Subject: Marymount California University – 6-Month Review of the Expanded Parking Lot Project (Planning Case No. ZON2003-00317)

Location: 30800 Palos Verdes Drive East

TO: HONORABLE MAYOR & CITY COUNCIL MEMBERS
FROM: JOEL ROJAS, AICP,  COMMUNITY DEVELOPMENT DIRECTOR
DATE: FEBRUARY 18, 2014
SUBJECT: MARYMOUNT CALIFORNIA UNIVERSITY – 6-MONTH REVIEW OF THE EXPANDED PARKING LOT PROJECT (PLANNING CASE NO. ZON2003-00317) / 30800 PALOS VERDES DRIVE EAST)
REVIEWED: CAROLYNN PETRU, ACTING CITY MANAGER 
Project Manager: Ara Mihranian, AICP, Deputy Community Development Director

Sheet PARKING LOT LIGHTING PLAN	
revisions	R&A No. 962401
	Date: 5/30/12
	Drawn:
	Checked:
	Consult. No:

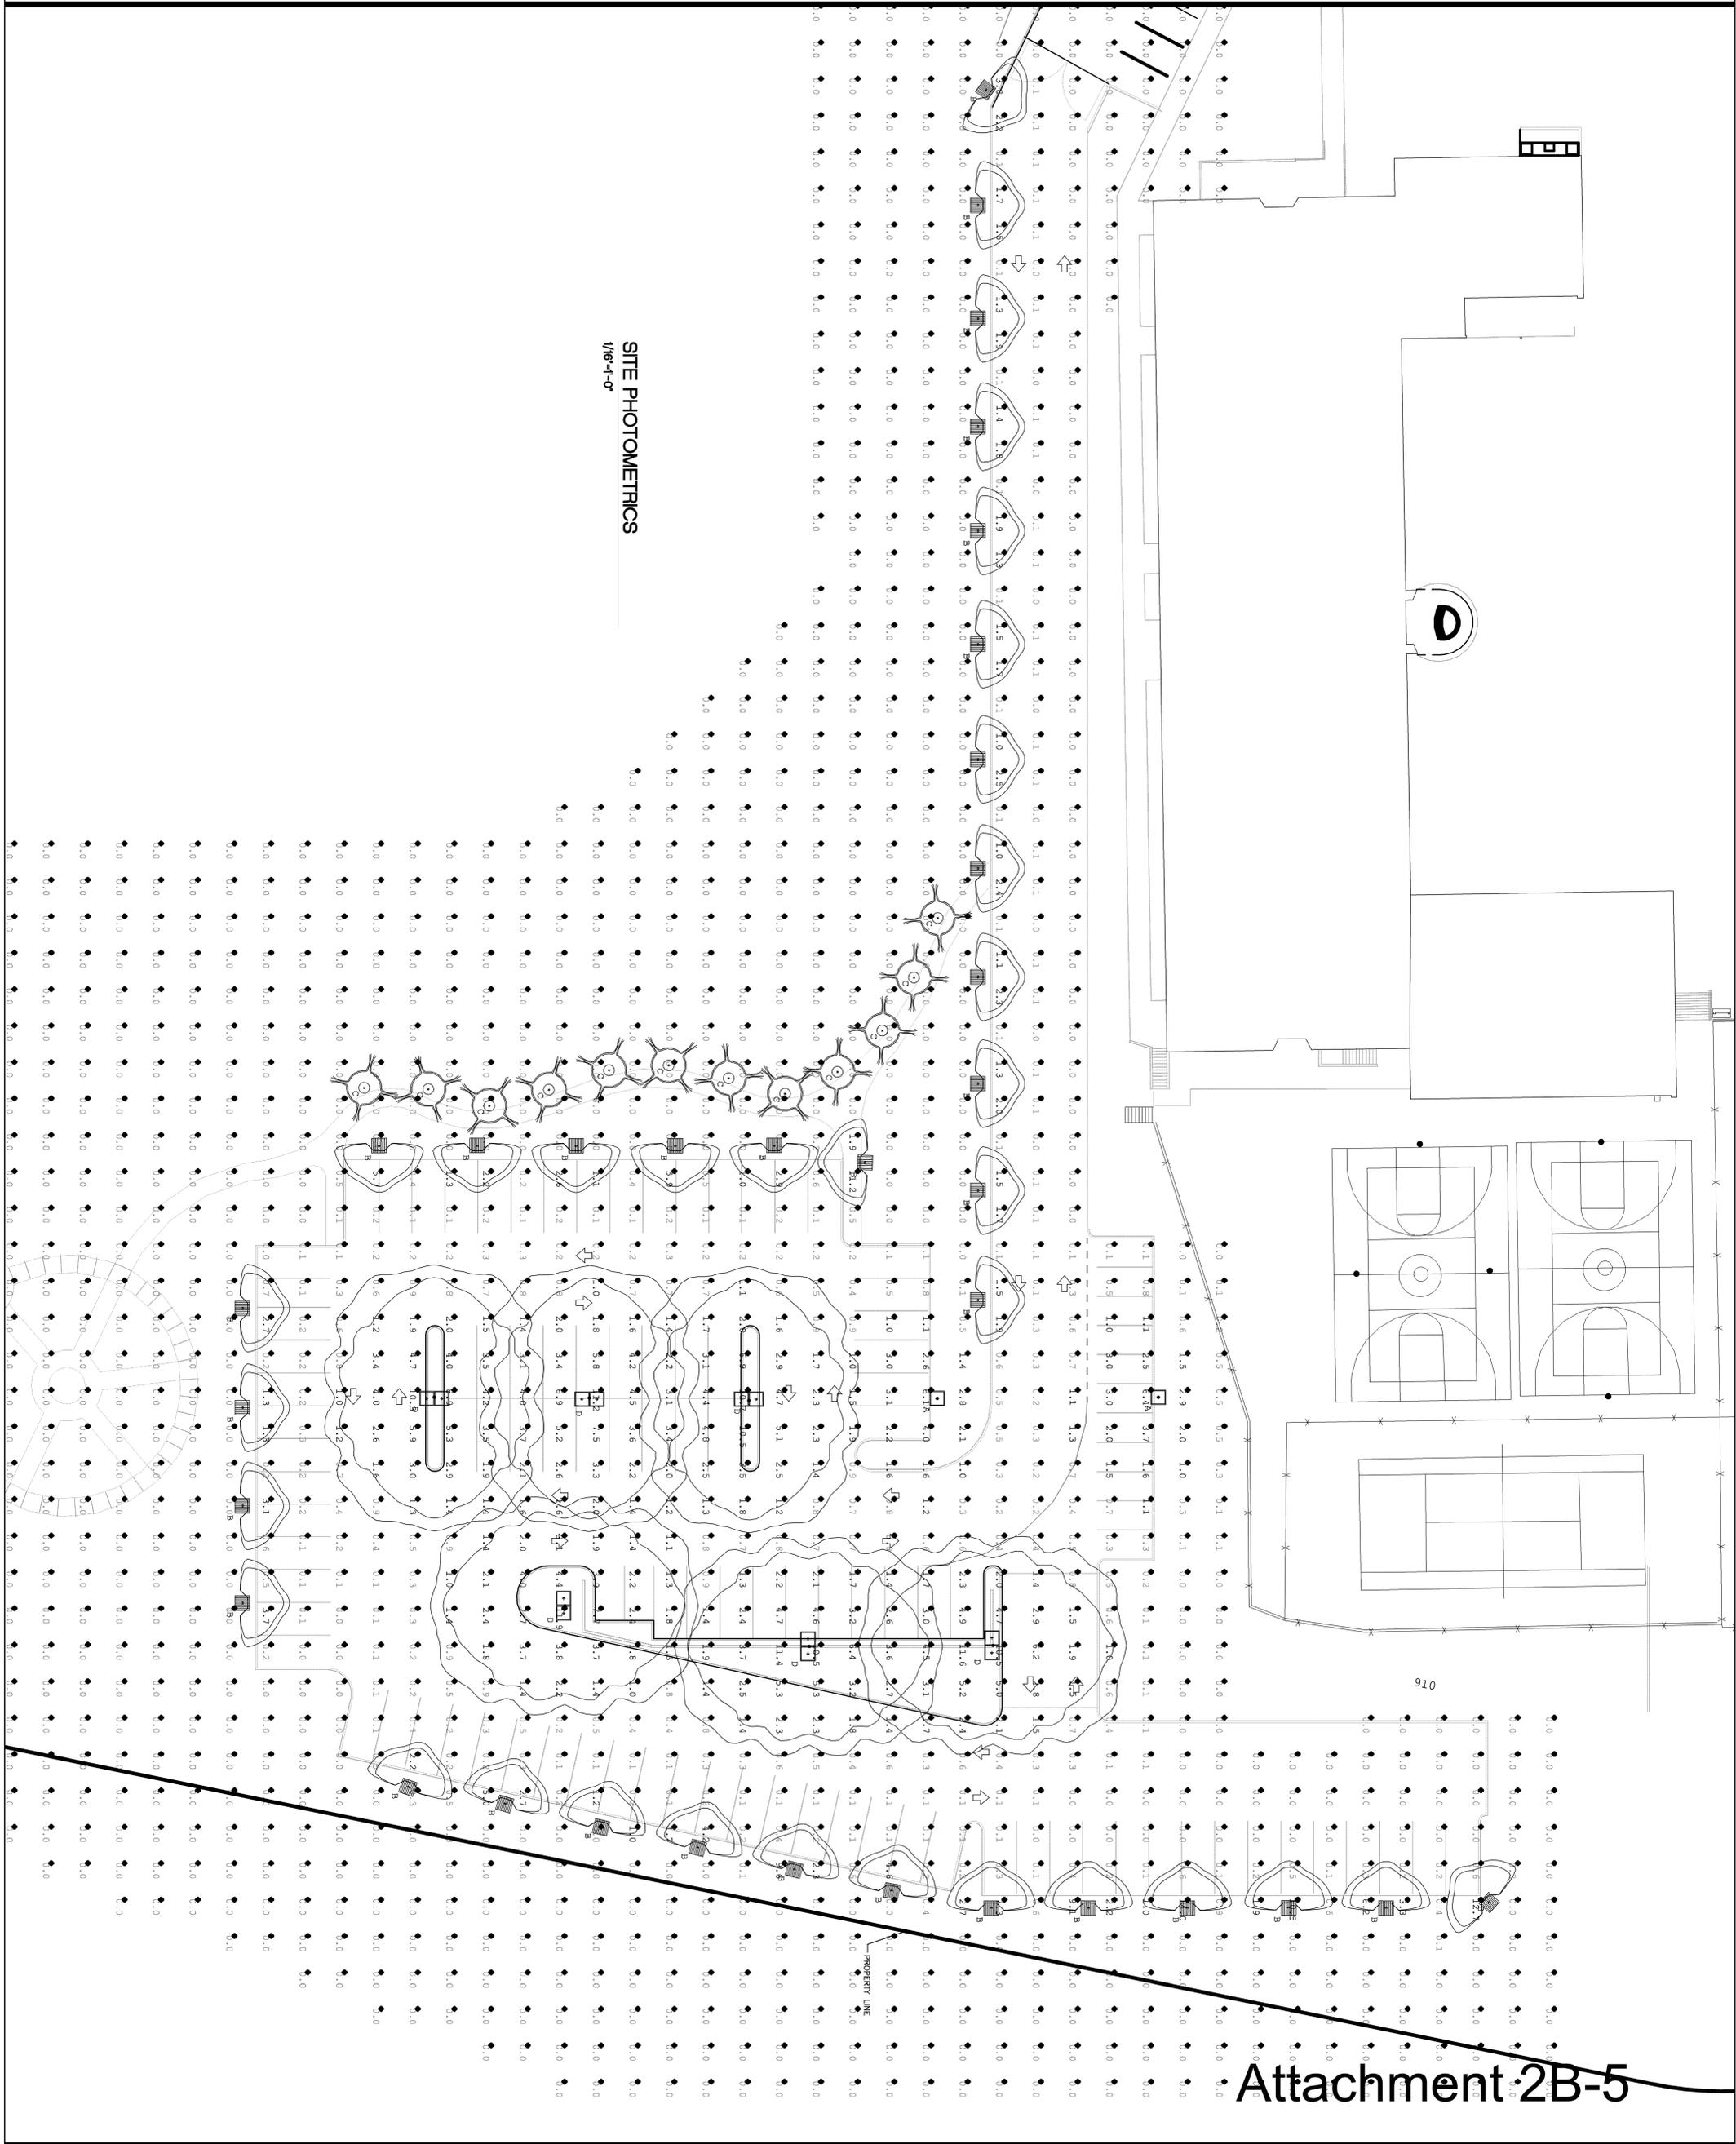
Once the parking lot lighting became operational, the City began to hear concerns from the downslope neighbors that the illumination of the parking lot is clearly visible and has changed the character of the night environment in the area. In response to these public concerns, Staff assessed the parking lot lighting and determined that the lights do not create a halo in the night sky nor shine into neighboring properties or onto the surrounding slopes, as required by the conditions of approval. This is evident at the perimeter of the parking lot where a visible a line exists between the illuminated parking lot and the dark slopes adjacent to the parking lot thereby demonstrating that the City approved photometric plan accurately depicted the lighting effect on the ground. Furthermore, in no case is the parking lot lighting shinning or spilling directly into the yards nor illuminating the neighboring properties. However, the illumination of the parking lot (between the light fixtures and the ground) is visible from the downslope properties along San Ramon Drive and Tarapaca Drive. Staff believes that the addition of a screening fence and hedge along the eastern and northern perimeter of the parking lot as discussed earlier will further minimize the impacts of the parking lot lights from these locations. In addition, Staff recommends that Condition No. 152 be amended so that the total current amount of visible light emitted by each parking lot light bulb (1700 lumens) is not increased in the future and requiring shields be installed around the fixtures of the 10-foot tall light standards, and requiring the parking lot lights be turned off at 9:00 pm (with the exception of the pedestrian

The light standards at the east parking lot, located within the lower tier, shall be limited to a height of 42-inches, as measured from adjacent finished grade. Pursuant to Condition No. 152, for security and safety reasons, the access driveway, pedestrian pathway and parking lot perimeter bollard lighting shall be permitted to be illuminated throughout the night. The 10-foot light standards located within the east parking lot, as shown on the City approved parking lot plans, shall be turned off nightly at 9:00 pm.

- 4) Requiring the 10-foot tall parking lot light fixtures to be shielded, limited to 1700 lumens per bulb, and turned off at 9:00 pm;
- 5) Requiring additional trash receptacles with lids and “no smoking” and “no littering” signs be installed in the East Parking Lot;

PLANTING PLAN
SCALE 1" = 20'-0"

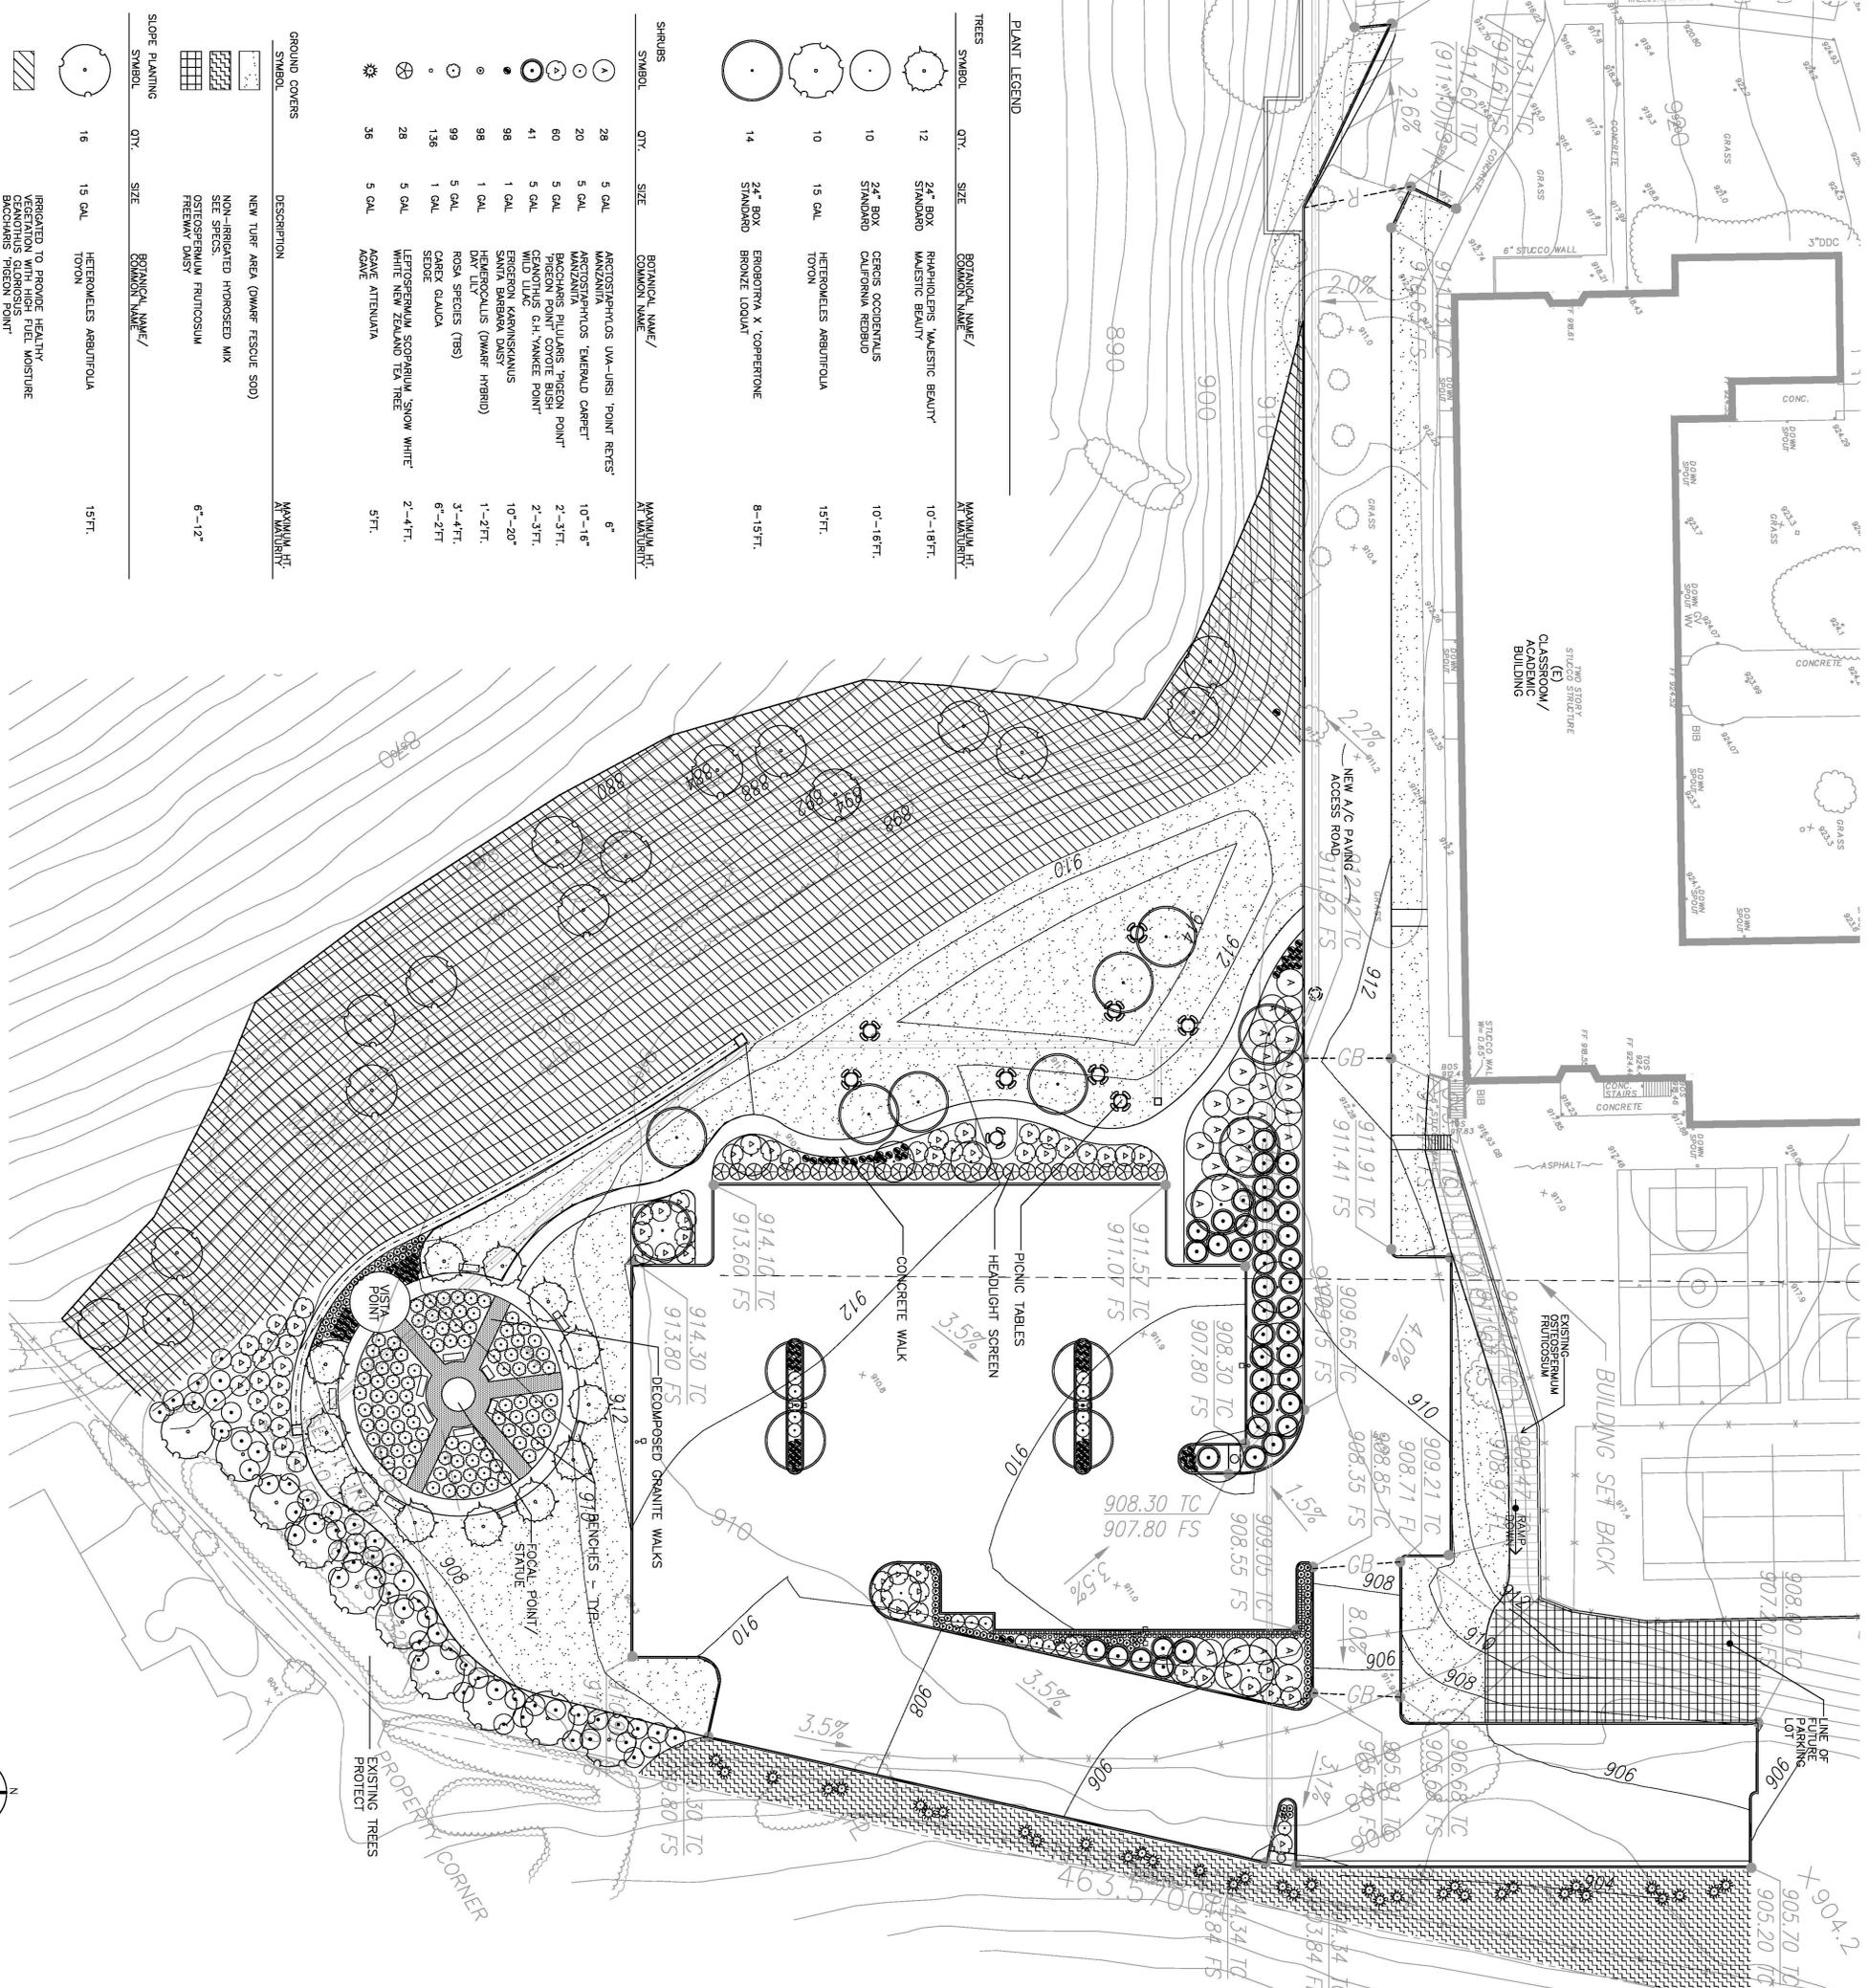
Per the approved plans, Marymount did install planting, albeit scarcely, around the perimeter of the parking lot but did not construct the 6-foot tall screening wall along the rear yards of San Ramon Drive (beginning at 2742 San Ramon Drive) because the entirety of the parking lot approved in 2010 was not constructed by Marymount. However, the residents downslope from Marymount are able to see the parking lot from their property, particularly their back yards, and the activities associated with its operation, such as vehicle movements, headlights, and students congregating to name a few. Additionally, some of the residents next to Marymount are experiencing an infringement of privacy, among other things, from the users of the parking lot due to its close proximity to their homes. In light of these public comments and Staff field observations, Staff believes added measures, such as the construction of a screening fence and hedge are now warranted to mitigate the described visual and privacy impacts, as well as other operational impacts stemming from noise, student congregation, and lighting which are described later in this report. Further, based on field observations and conversations with the neighbors, Staff does not believe that the recommended screening will result in a significant view impairment from the adjoining properties. As such, Staff specifically recommends the following amendments to Fence, Wall and Hedge Condition No. 173:

By April 18, 2014, the applicant shall construct install a 6-foot tall vinyl screening wall-fence finished in an earth tone color and an 8-foot tall hedge along the College's eastern property line eastern and northern portions (closest to 2750 San Ramon Drive) of the parking lot, as deemed acceptable by the Community Development Director, as depicted on the approved site plan, beginning at the southwest corner property line for Lot 26 (2742 San Ramon Drive / Tooley property). Specifically, the fence shall be placed within 3 feet of the parking lot curb

Marymount Parking Lot

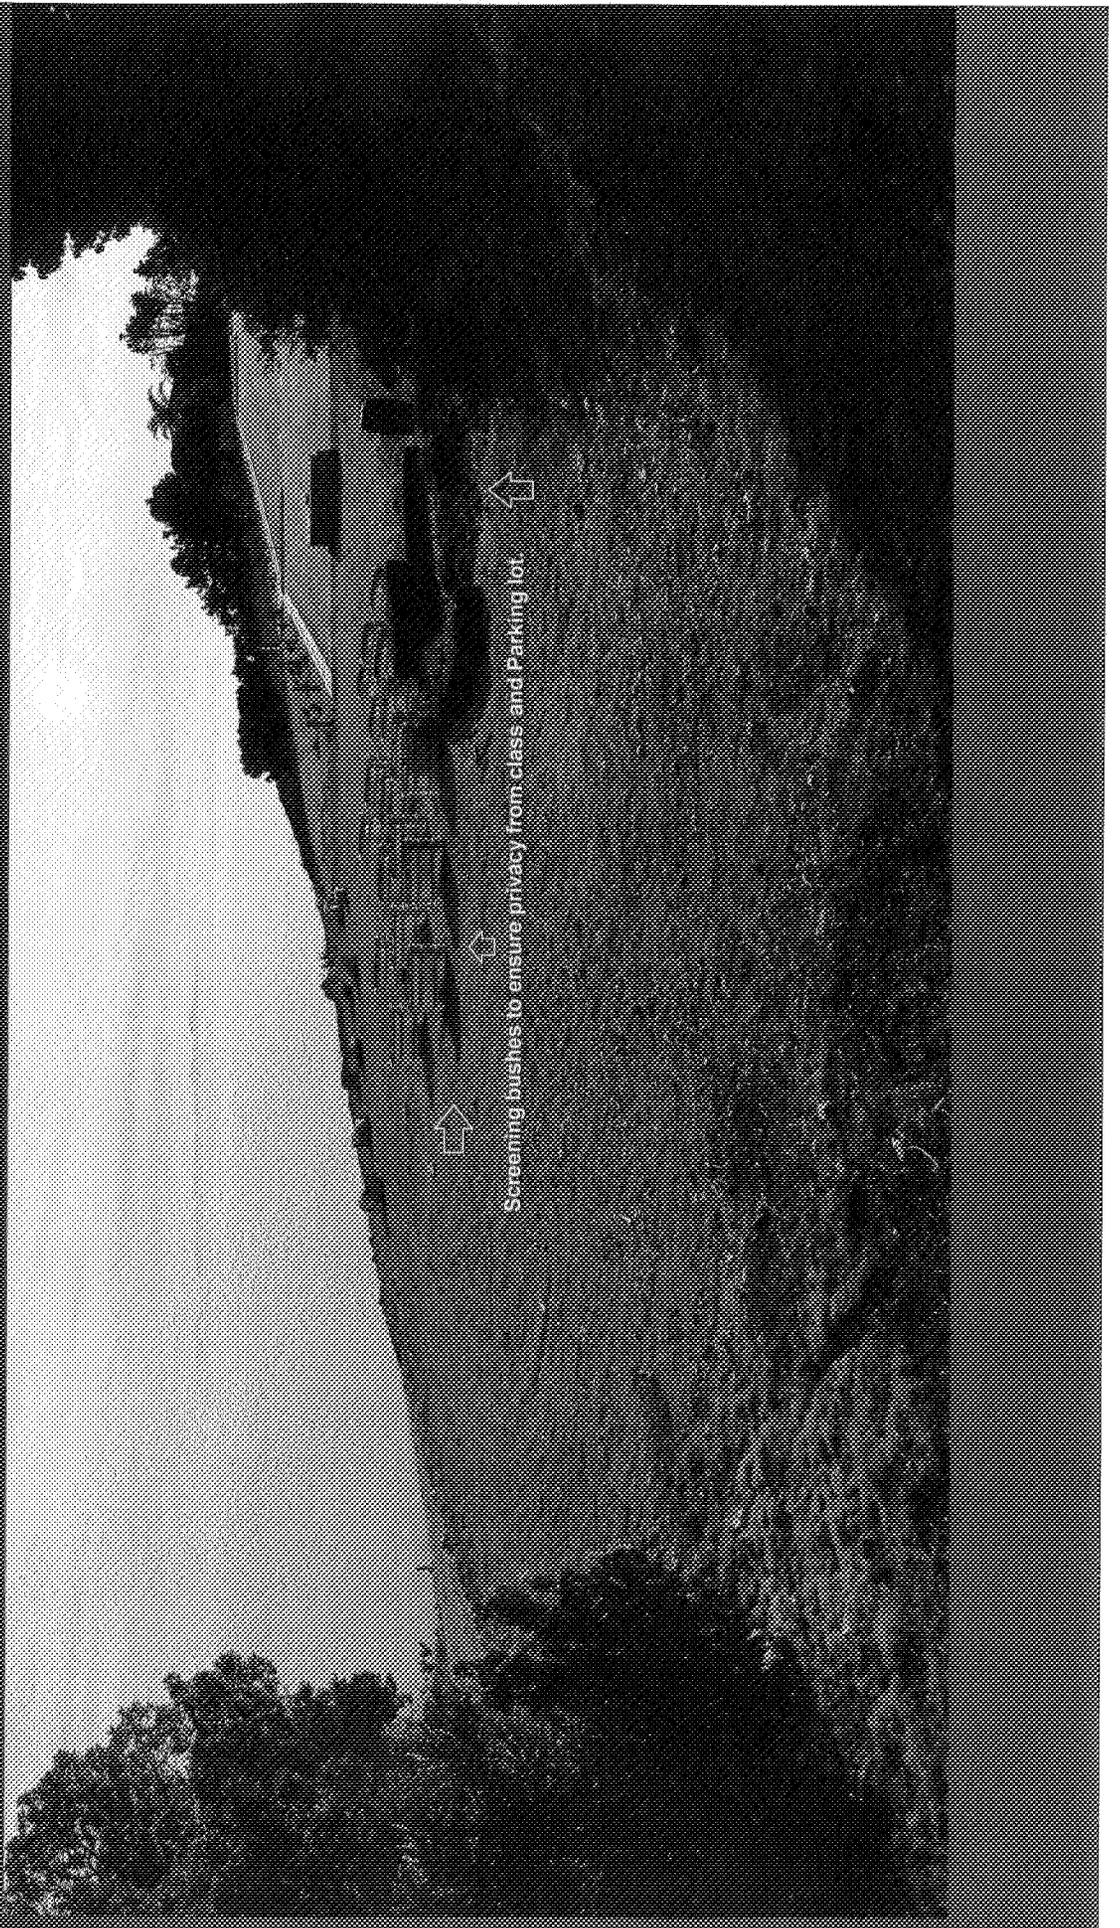
- RPV City recommendation – Parking lot 261ft from the Harris Spa & Deck.
- City Council approved 80ft from our deck because they thought that 80ft provided sufficient privacy. You will see from the following pictures that it is not.
- Marymount now wants an outdoor classroom half the distance closer to our Spa & Deck.
- There has to be a better location choice than 40ft from a neighbors Spa & Deck.

**Any Fence or Hedge on the Ridgeline will block 50% of
our Ocean View.**

If the City does not want to enforce the wishes of the City Council to ensure our privacy, a hedge would be needed to screen parking lot and class area

Screening bushes to ensure privacy from class and Parking lot.
